SUBDIVISION REVIEW SHEET**CASE NO.:** C8-2020-0033**COMMISSION DATE:** June 22, 2021**SUBDIVISION NAME:** Saddle Ridge at Wildhorse Ranch Preliminary Plan**ADDRESS:** 10621 Blue Bluff Road**APPLICANT:** Heart of Manor LP**AGENT:** Kimley-Horn and Associates (Kevin Burks)**ZONING:** Wildhorse Ranch PUD**NEIGHBORHOOD PLAN:** Wildhorse Ranch PUD**AREA:** 82.24 acres**LOTS:** 248**COUNTY:** Travis**DISTRICT:** 1**WATERSHED:** Gilleland Creek**JURISDICTION:** Full Purpose**SIDEWALKS:** Sidewalks will be constructed along all internal streets and the subdivision side of Blue Bluff Road.**VARIANCES:** Variances from LDC § 25-8-341, to allow cut over four feet, and LDC § 25-8-342, to allow fill over four feet.**DEPARTMENT COMMENTS:**

CITY OF AUSTIN –DEVELOPMENT SERVICES DEPARTMENT
SUBDIVISION APPLICATION – MASTER COMMENT REPORT

PROJECT NAME: Saddle Ridge at Wildhorse Ranch
LOCATION: 10621 BLUE BLUFF RD

SUBMITTAL DATE: May 24, 2021
FINAL REPORT DATE: June 17, 2021

PRELIMINARY PLAN
(1 OF 2)

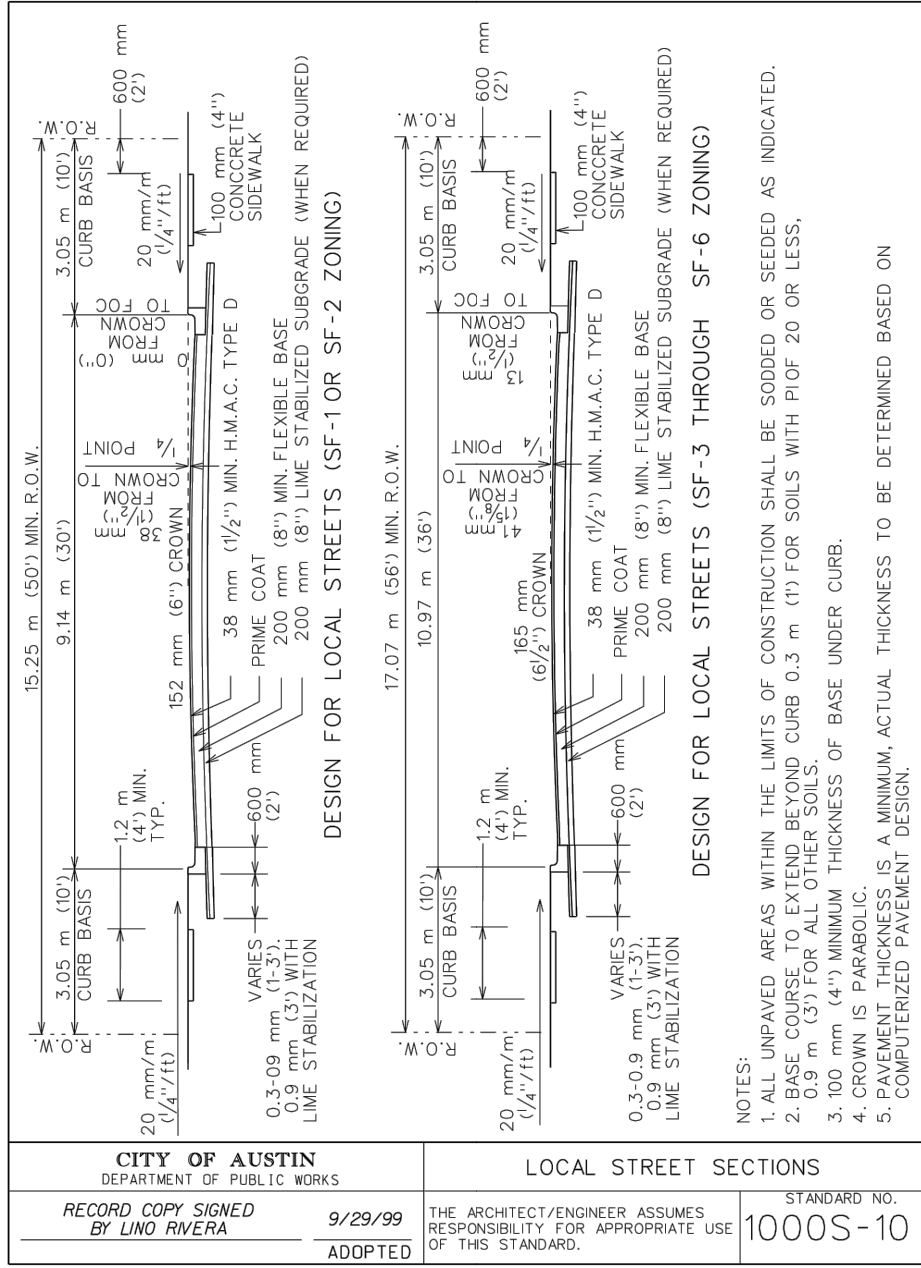
SR 1: Update the Case # to C8-2020-0033 in the bottom right hand corner of each sheet. (LDC § 25-1-83)

SR 4: Revise C.O.A. approval block (LDC § 25-1-83):

PRELIMINARY SUBDIVISION APPROVAL SHEET 1 OF 3.

FILE NUMBER: C8-2020-0033. APPLICATION DATE _____

APPROVED BY THE LAND USE COMMISSION ON _____, 2021.

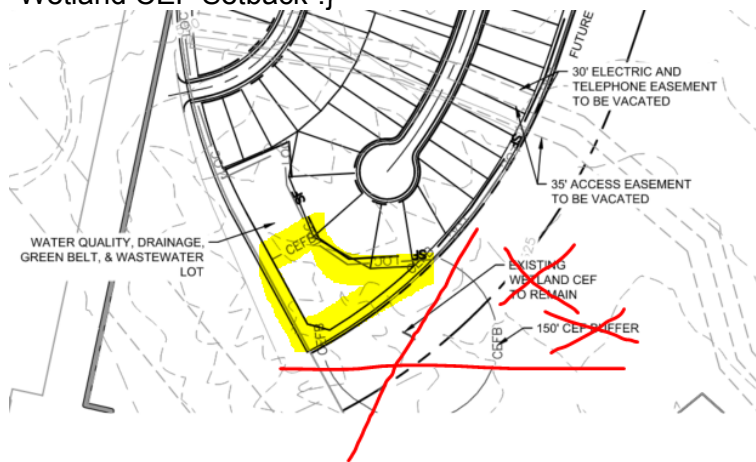
FYI A site visit was conducted by Miranda Reinhard and Andrew Clamann on June 11, 2021 and additional wetland CEFs outside of the limits of the preliminary plan were observed.

WB1. Update0. This project does not comply with Critical Environmental Feature protection requirements for off-site wetland CEFs. [LDC 25-8-281; LDC 25-8-282; ECM 1.10] {To clear this comment, please remove the wetland CEF, CEF setback, and associated callout notes that are outside the limits of the preliminary plan (see red X's below). Please clarify that the CEF setback (CEFB) within the limits of the preliminary plan is a closed polygon (highlighted in yellow below) and relabel it as "Wetland CEF Setback".}
